**ADDENDUM NO. 2
TO THE
CONTRACT DOCUMENTS AND SPECIFICATIONS
FOR
NEW SIDEWALK CONSTRUCTION BETWEEN US 98 AND CR 13 ON CR 44 AND
MANLEY ROAD
ALDOT PROJECT NO. TAPOA-TA17(937)
CITY BID NO. 028-19, CITY PROJECT NO. PW021-17**

**TAPOA-TA17(937) FAIRHOPE 2017 TAP NEW SIDEWALK
BETWEEN US 98 AND CR13**

REFERENCE PROJECT NO	FISCAL YEAR	SHEET NO
TAPOA-TA17(937)	2019	2E

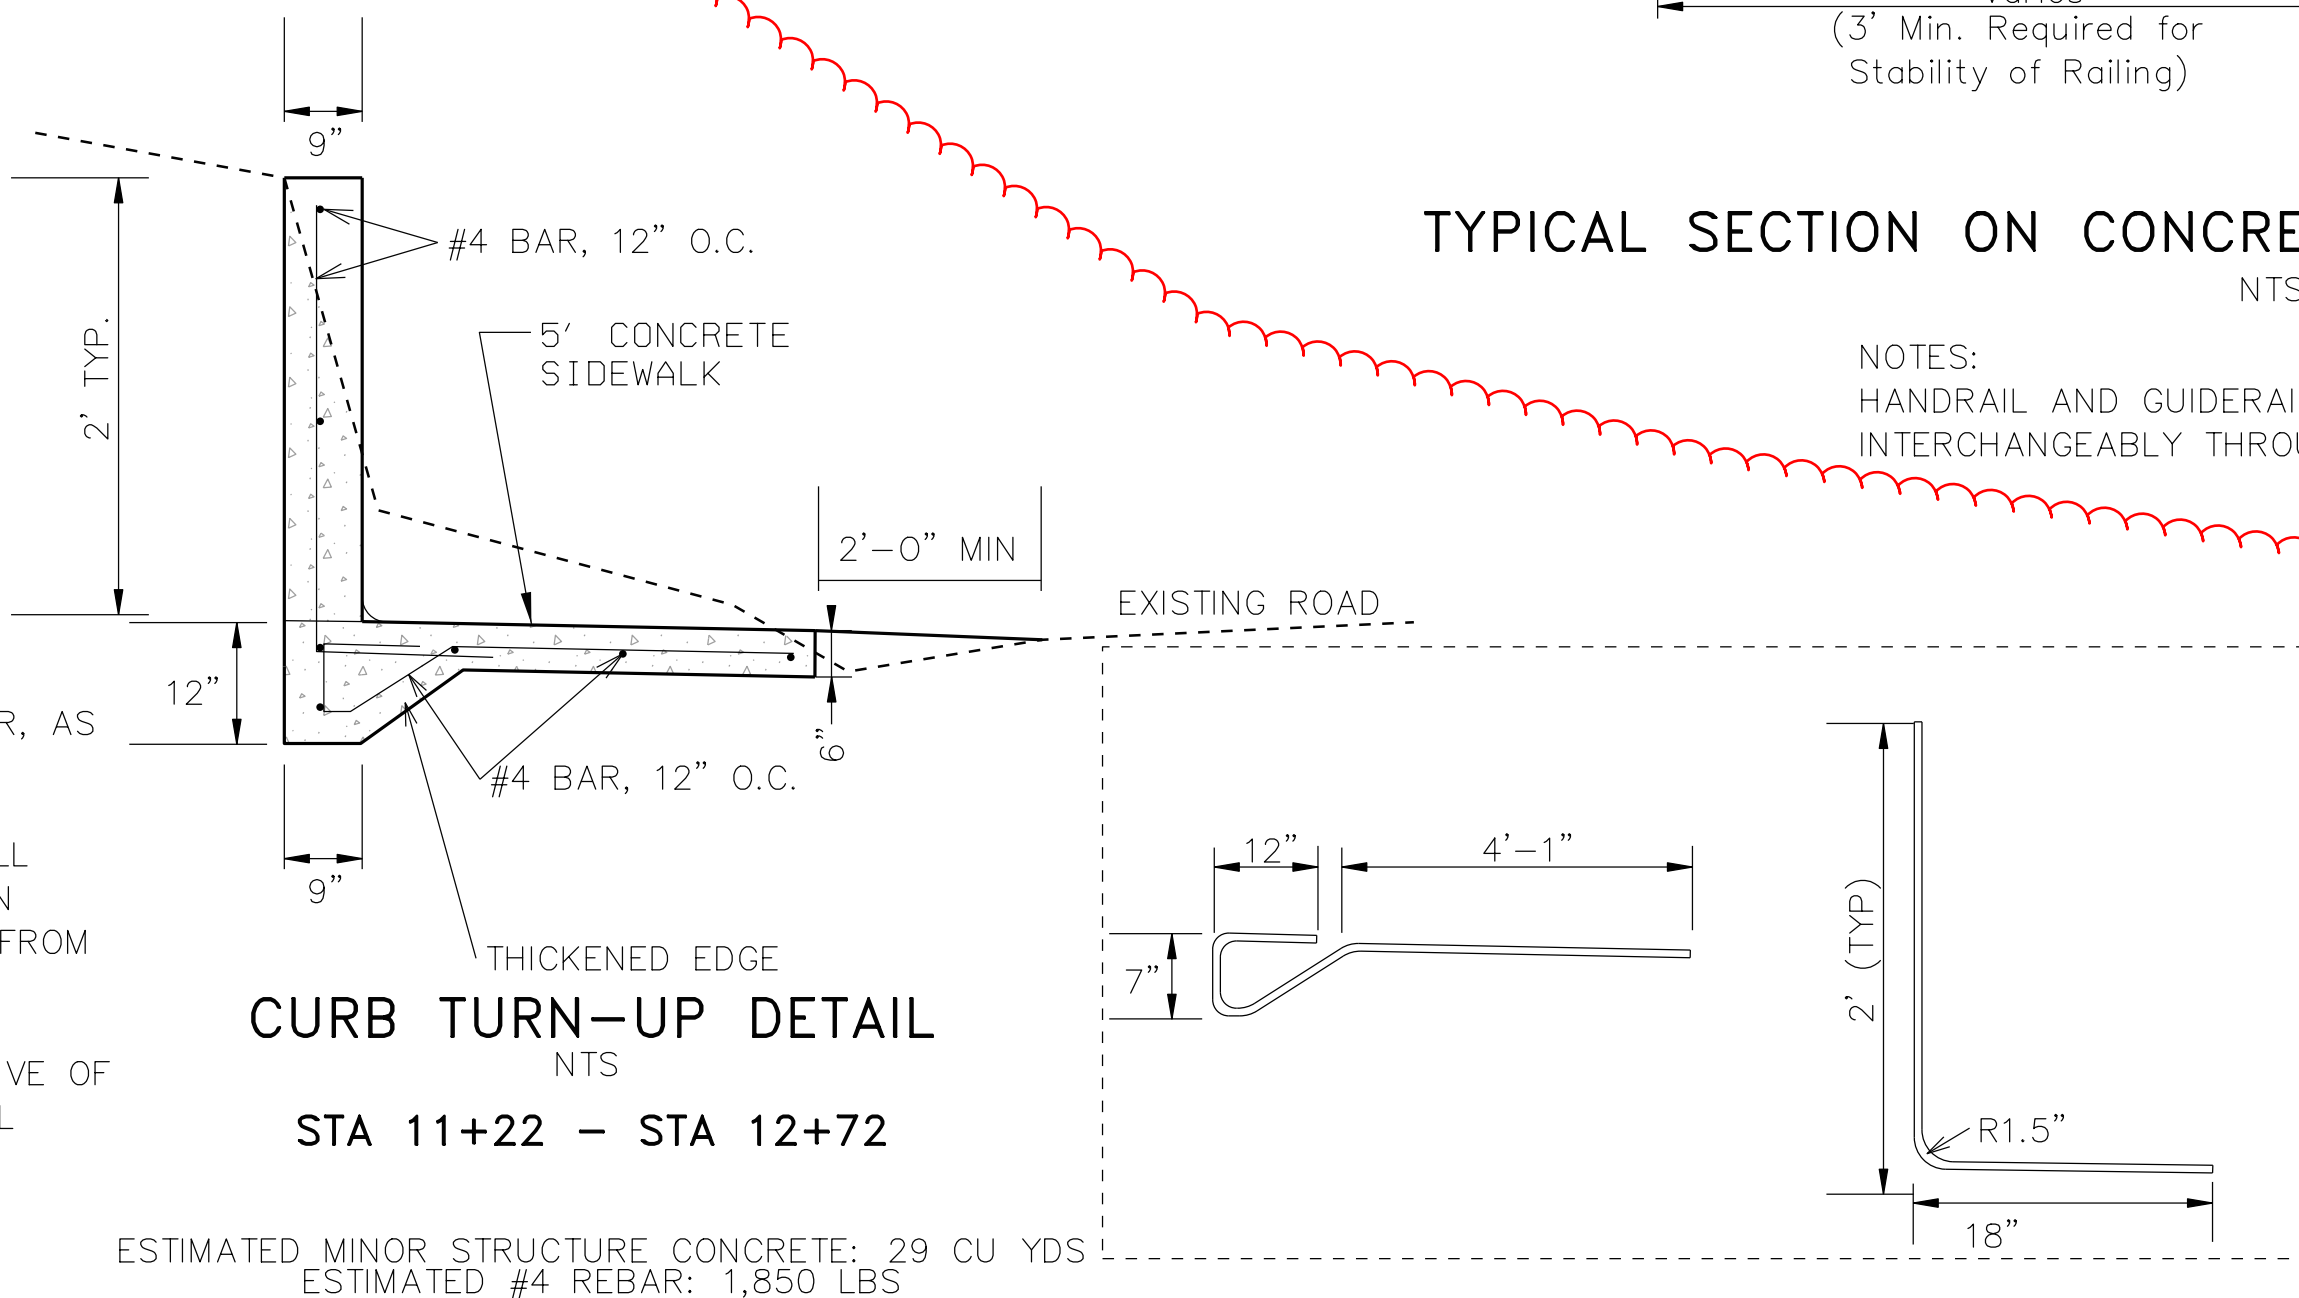
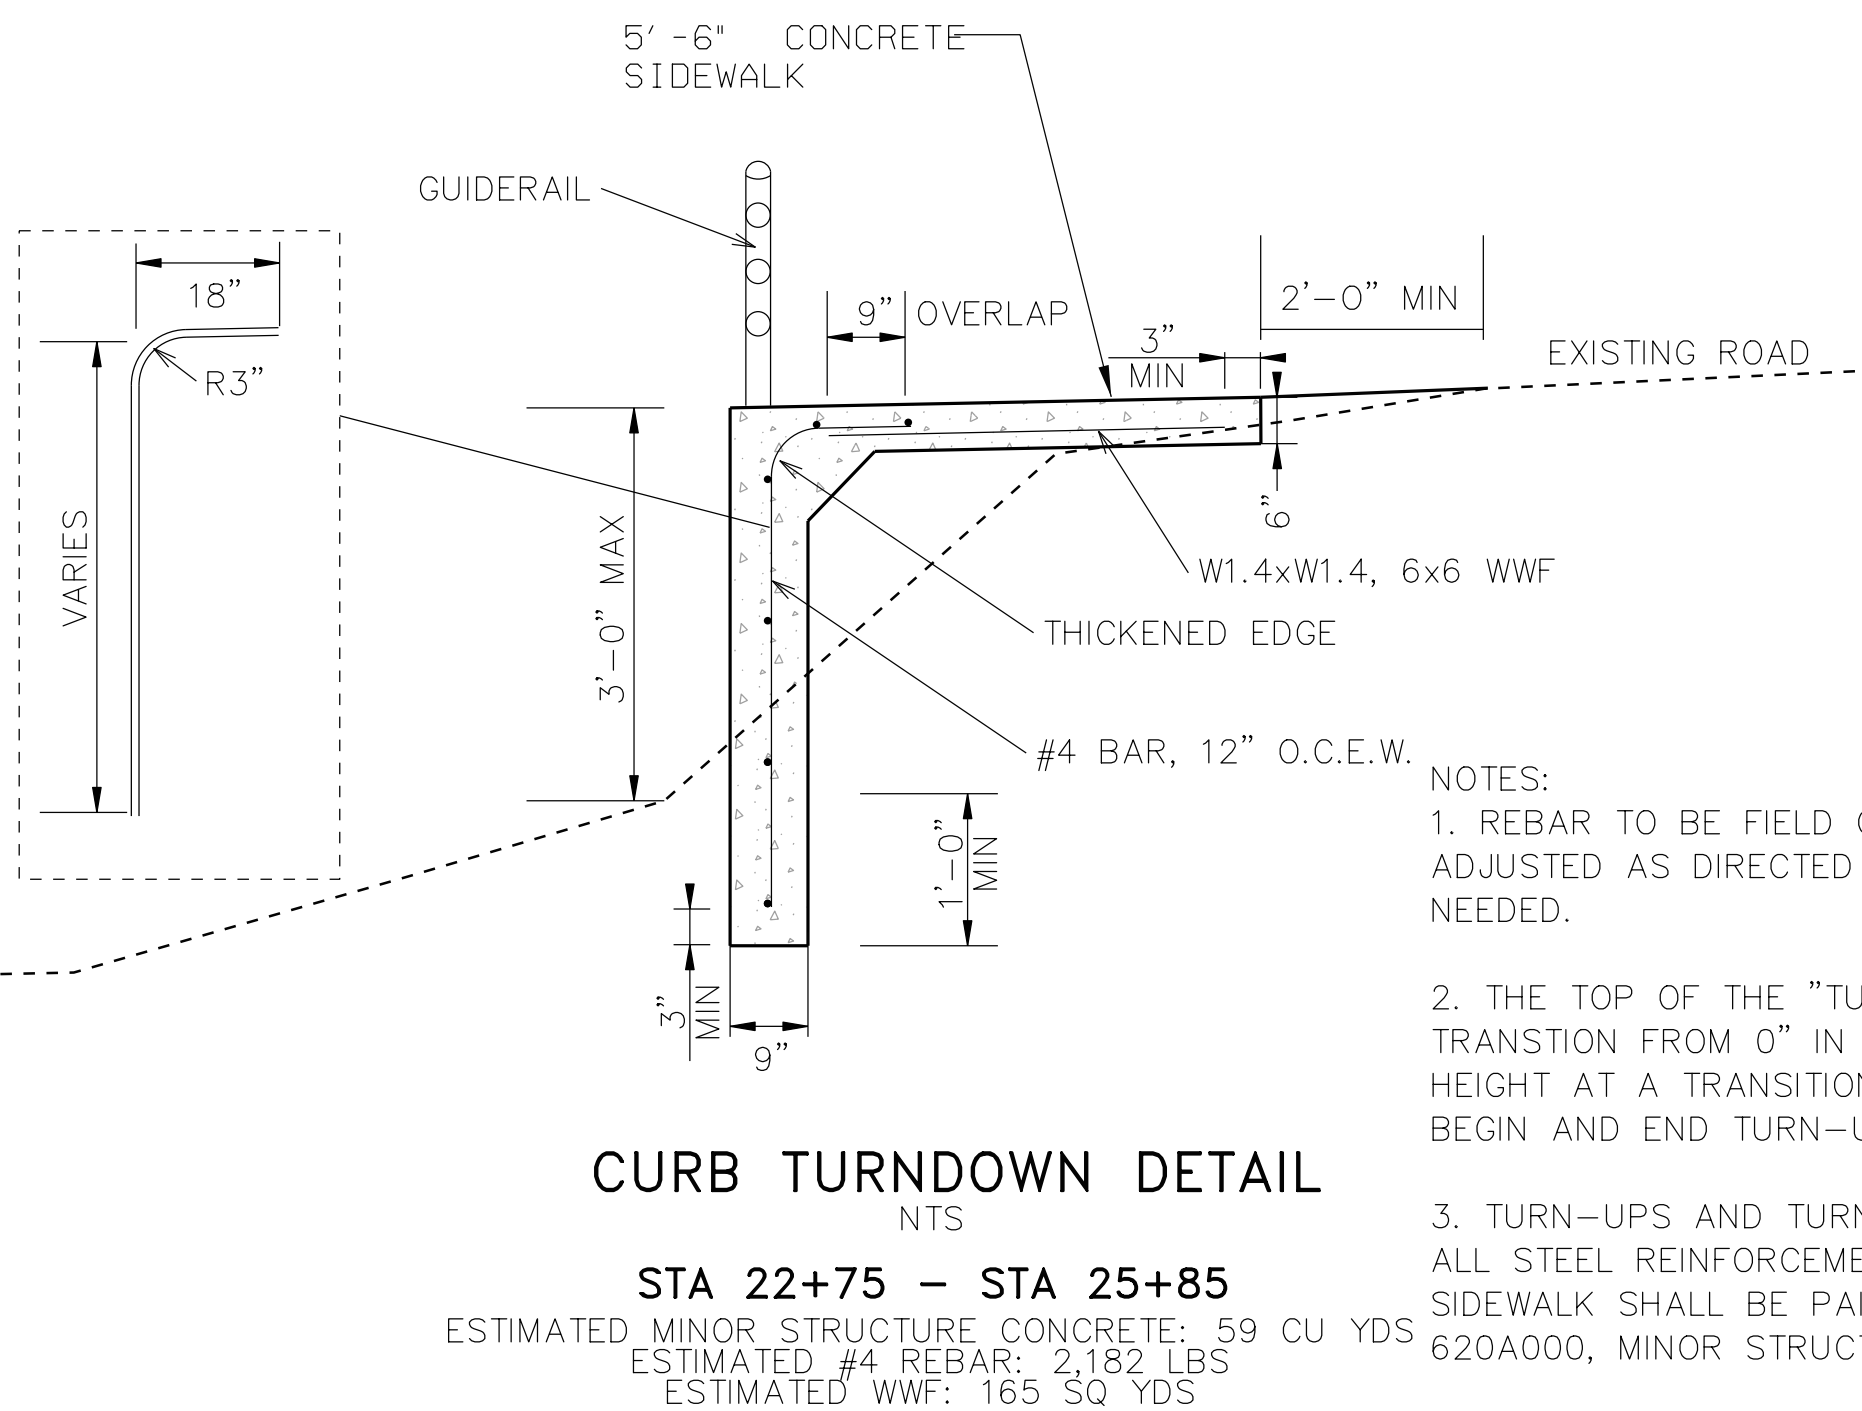
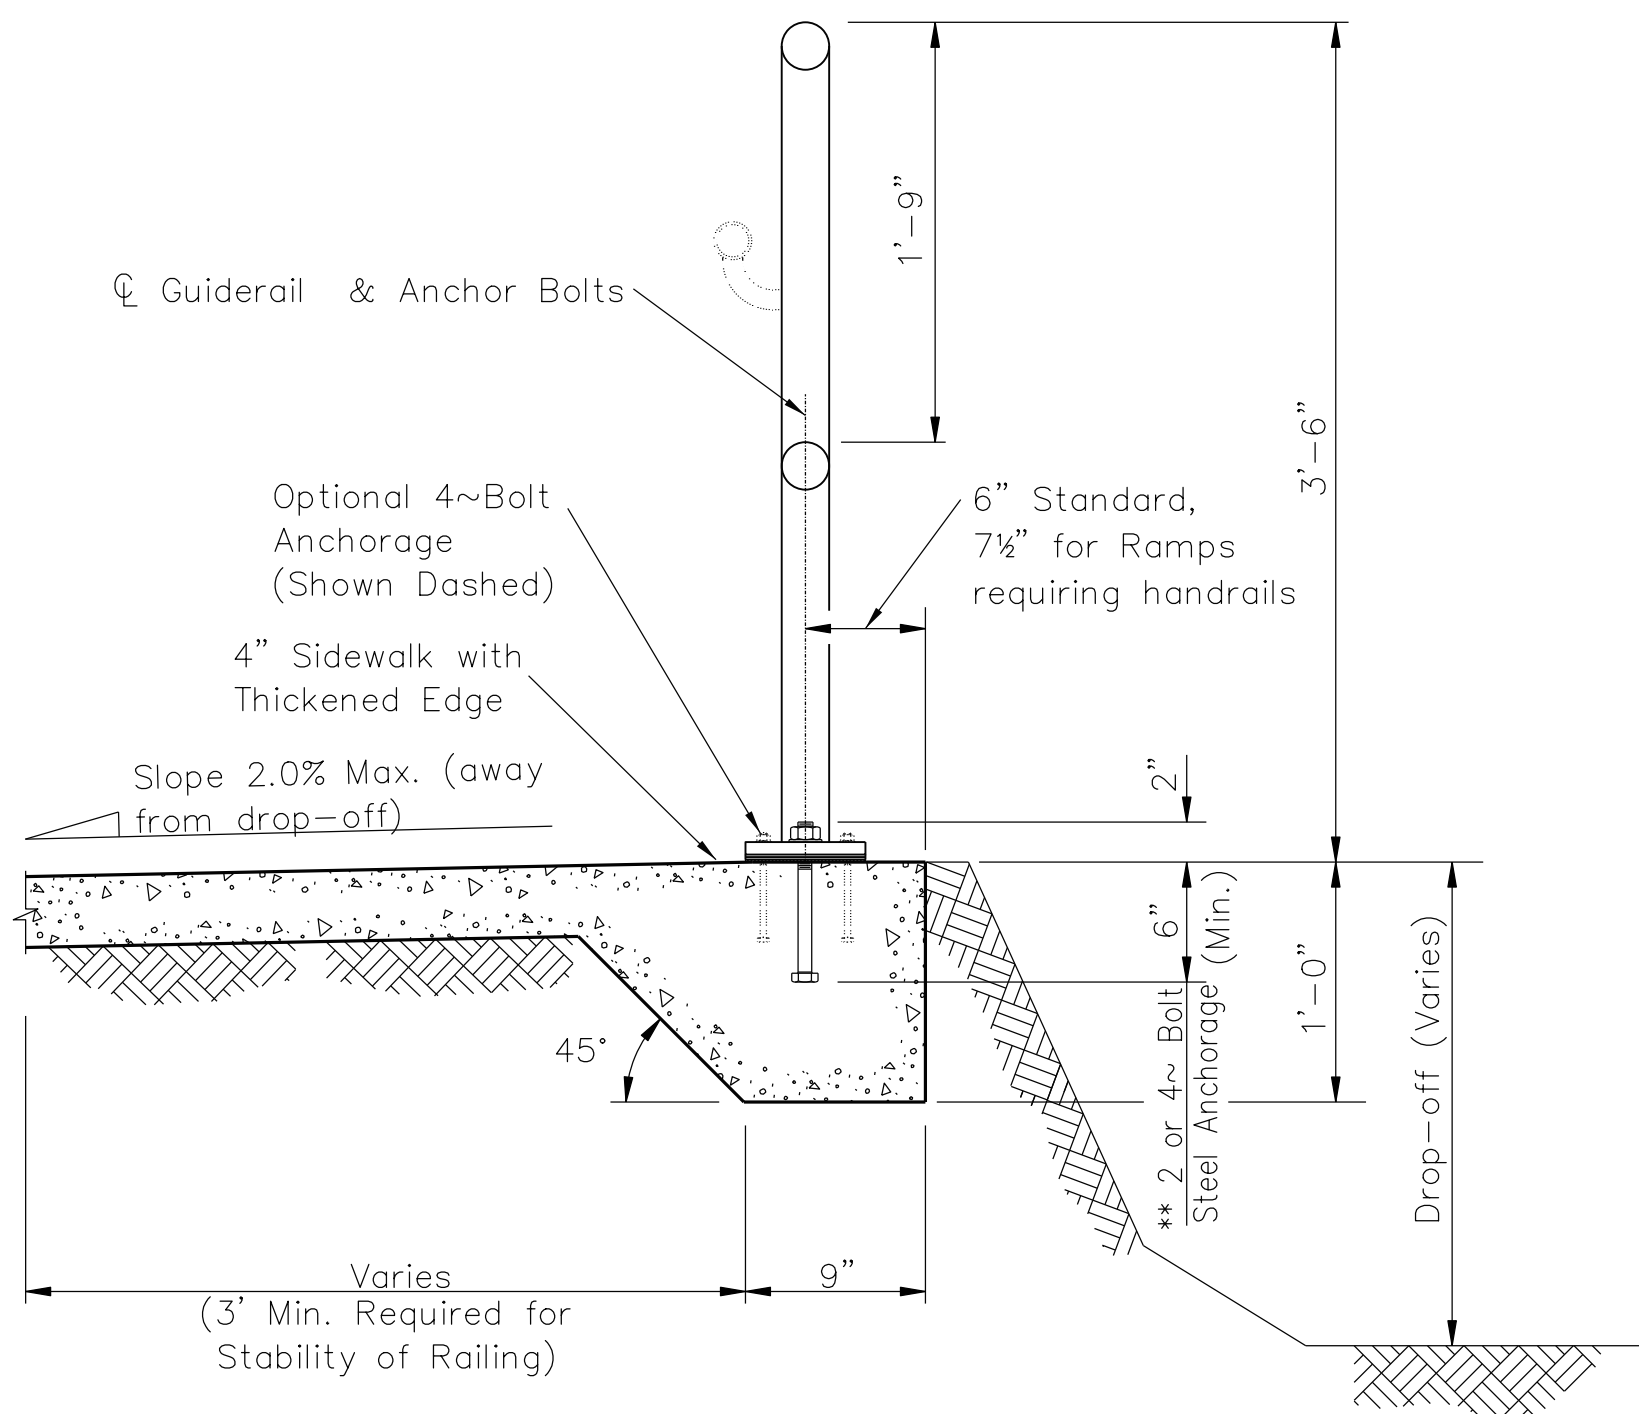
- A. Plan Details, Sheet 2E shall be replaced with the sheet attached.**
- a. Details for both the "Turn-Up" and Turndown detail have been revised to add steel reinforcement requirements. Estimates for both steel and minor structure concrete have also been added.
- B. Summary of Quantities, Sheet 3 Shall be revised as follows:**
- a. Item 614A-000, Slope Paving has been deleted.
 - b. Item 618A-000, Sidewalk, 4" Thick has been revised to 2,715 Square Yards.
 - c. Item 620A-000, has been revised to 98 Cubic Yards.
- C. Summary of Quantities, Sheet 3A Shall be revised as follows:**
- a. Item 614A-000, Slope Paving has been deleted.
 - b. Item 618A-000, Sidewalk, 4" Thick has been revised to 2,715 Square Yards.
 - c. Item 620A-000, has been revised to 98 Cubic Yards.
